# Interpretation of CSF warnings #2

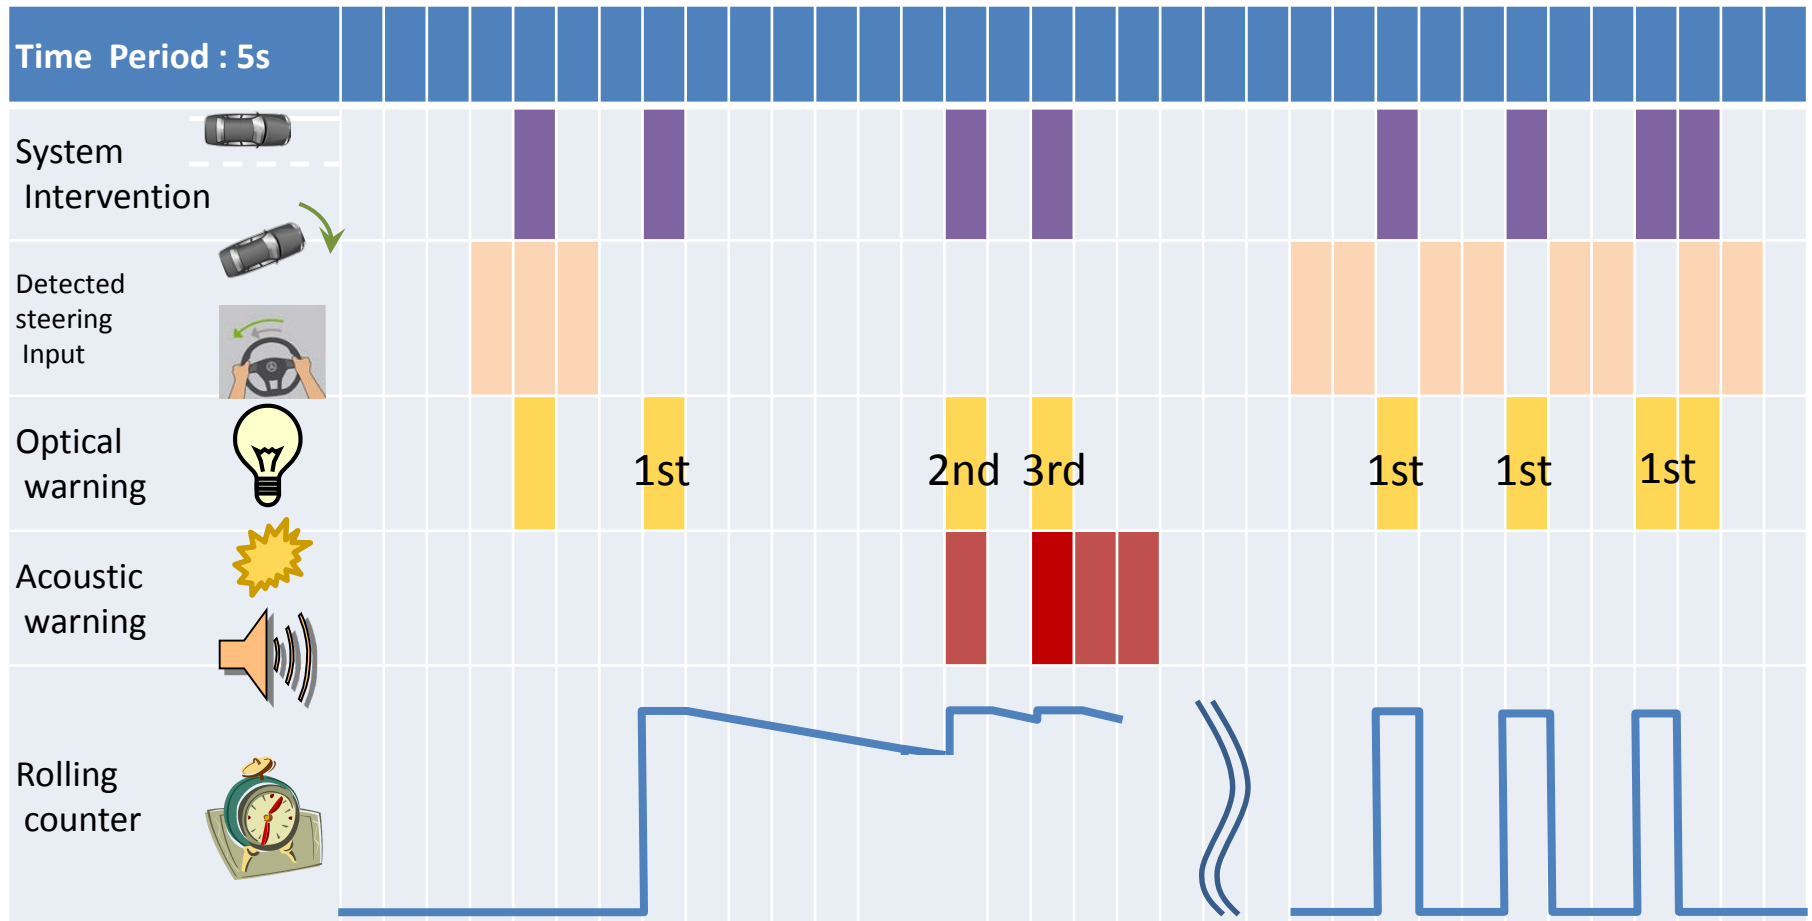
5.1.6.2.2.2. In the case of two or more consecutive interventions within a rolling interval of 180 seconds and in the absence of a steering input by the driver ~~during these interventions~~, an acoustic warning shall be provided by the system during the second and any further intervention within ~~this a~~ rolling interval of 180 seconds. Starting with the third intervention (and subsequent interventions) the acoustical signal shall continue for at least 10 seconds longer than the previous warning signal.

In case of a system designed not to assist steering when hands-off detected

Rejected

# Interpretation of CSF warnings #2

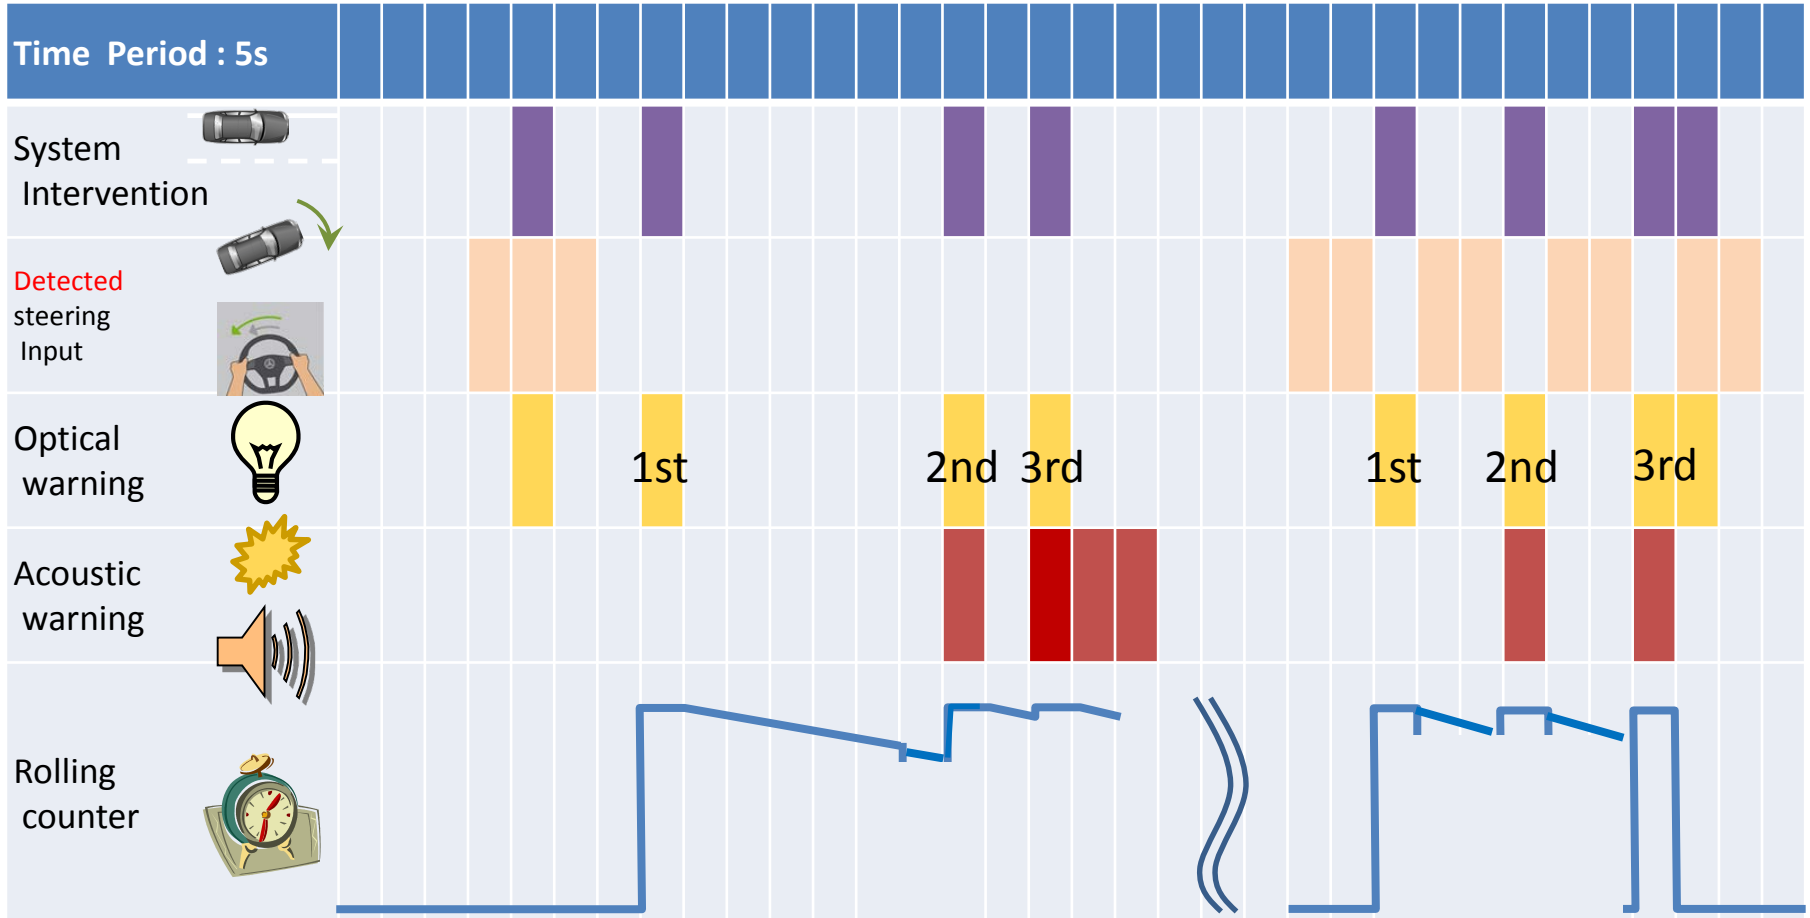
5.1.6.2.2.2. In the case of two or more consecutive interventions within a rolling interval of 180 seconds and in the absence of a steering input by the driver during the intervention, an acoustic warning shall be provided by the system during the second and any further intervention within a rolling interval of 180 seconds. Starting with the third intervention (and subsequent interventions) the acoustical signal shall continue for at least 10 seconds longer than the previous warning signal.

In case of a system designed not to assist steering when hands-off detected

Agreed
